Re: St. Lucie Unit 1  
Docket No. 50-335  
In-Service Inspection Plans  
RAI Reply for Fourth Ten-Year Interval Unit 1 Relief Request 2

St. Lucie Unit 1  
Fourth Inspection Interval  
Relief Request Number 2 RAI Response

St. Lucie Unit 1  
FOURTH INSPECTION INTERVAL  
RELIEF REQUEST NUMBER 2 Revision 1

USE OF WELD OVERLAYS AS AN ALTERNATIVE REPAIR TECHNIQUE

Fig. 1 Acceptance Examination Volume and Thickness Definitions

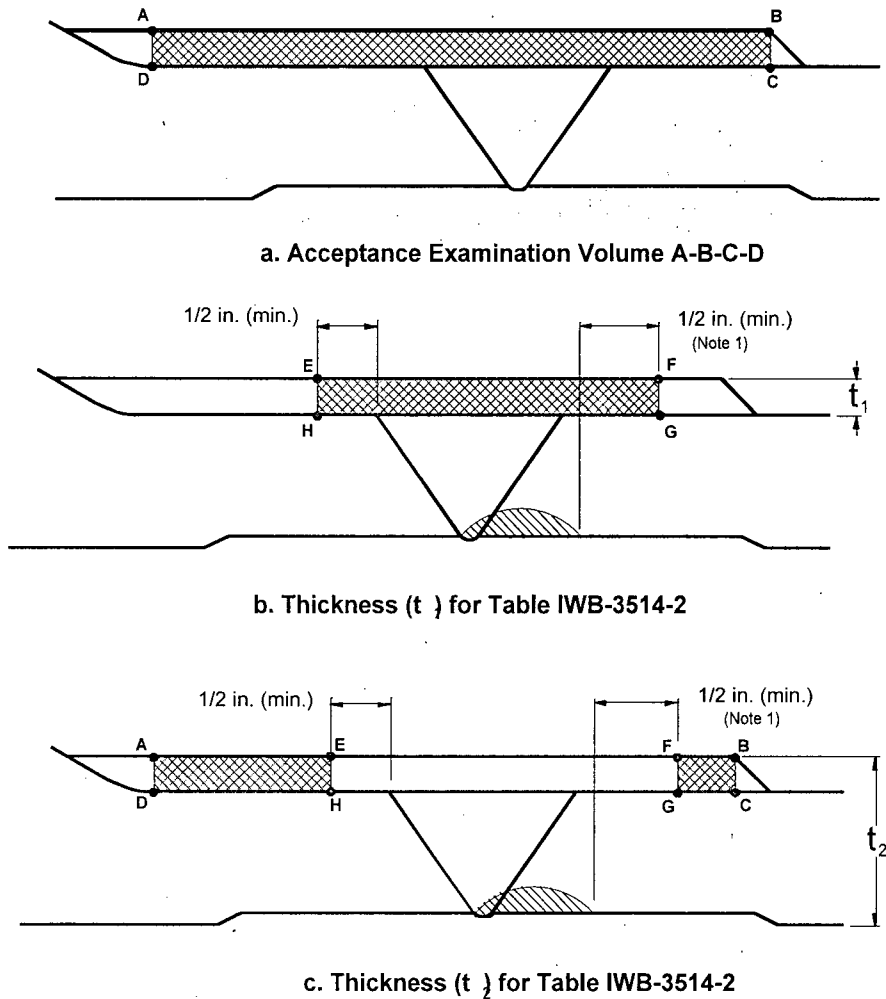
Paragraph 3(a)(3) of Attachment 2 states that "for planar indications outside this examination volume, the nominal wall thickness shall be " $t_2$ " as shown in Fig 1(c) for volumes A-E-H-D and F-B-C-G." For the cast stainless steel material, UT is not currently qualified to examine the base metal following weld overlay installation. Initial 100% through-wall axial and circumferential flaws are assumed for both SWOL design and flaw growth evaluations at all nozzle locations where SWOLs will be installed. " $t_2$ " is  $\frac{1}{2}$  in. outside the PWSCC susceptible DMW. The portion of the pipe, safe end or nozzle material outside the PWSCC susceptible material is assumed unflawed. These volumes are also outside any other Section XI ISI volume other than associated with the original weld ISI as shown in Figure IWB-2500-8(c) so service related flaws therein are not expected to occur. Surface examination is also performed on these areas before the SWOLs are applied to verify absence of surface flaws. The volume of the overlay which is more than  $\frac{1}{2}$  inch from the susceptible region is treated as a cross section which is the SWOL thickness plus the original underlying base metal wall thickness. The acceptance standard for a flaw in the SWOL from Table IWB-3514-2 is thus based on " $t_2$ ". The approach is consistent with other examinations in Section XI including pipe to pipe welds where the examination volume does not include the entire thickness but the acceptance

criteria does. Furthermore indications in the overlay will be required to be sized. This requirement will assure that the indications which may extend into the base metal are not excluded.
